Proposal for amendment to Regulation No. 17

I. Proposal

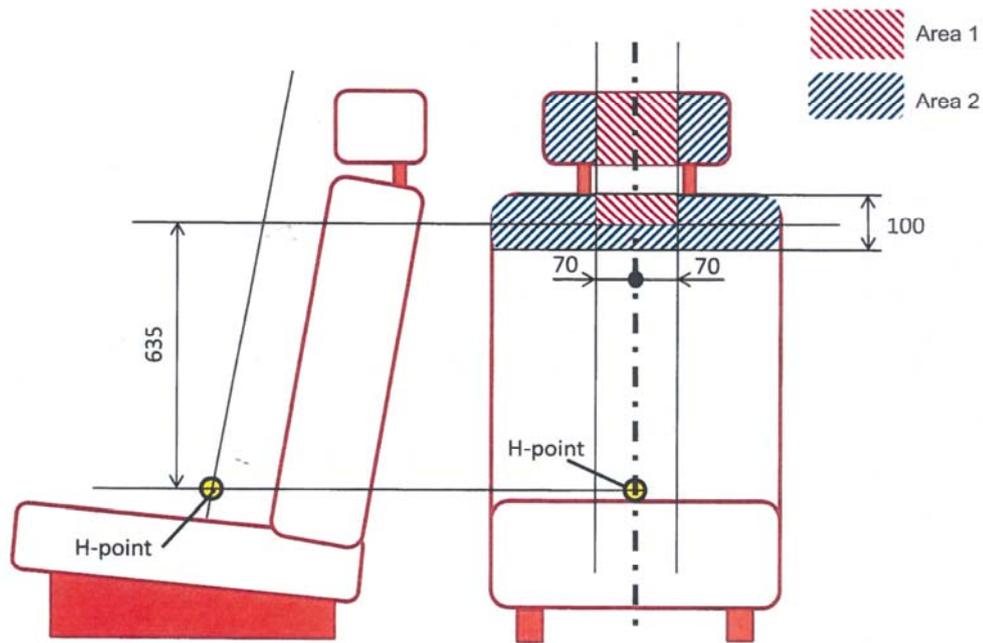
4. Up to now only Area 1 has to pass energy absorption criteria, however if we will allow in Reg.16 to contact any rigid part in front of the dummy then it will be necessary to involve also Area 2 !

Here under are indicated the Area 1 and Area 2 for seats with head restraints to have a better idea of this proposal.

"5.2.3. The rear parts of seats situated in **as well area 1**, defined in paragraph 6.8.1.1. ~~below, as area 2, as defined in paragraph 6.8.1.2.~~, shall pass the energy dissipation test in accordance with the requirements of Annex 6 to this Regulation.

2.5 mm in area 1 **and area 2**,
~~5.0 mm in area 2~~,
3.2 mm in area 3.

"5.5.2. Parts of the front ~~and rear faces~~ of the head restraints situated in area 1, as defined in paragraph 6.8.1.1.3. ~~below~~ shall pass the energy absorption test. **The rear of the head restraints situated in as well area 1, as defined in paragraph 6.8.1.1., as area 2, as defined in paragraph 6.8.1.2., shall pass the energy absorption test.**"
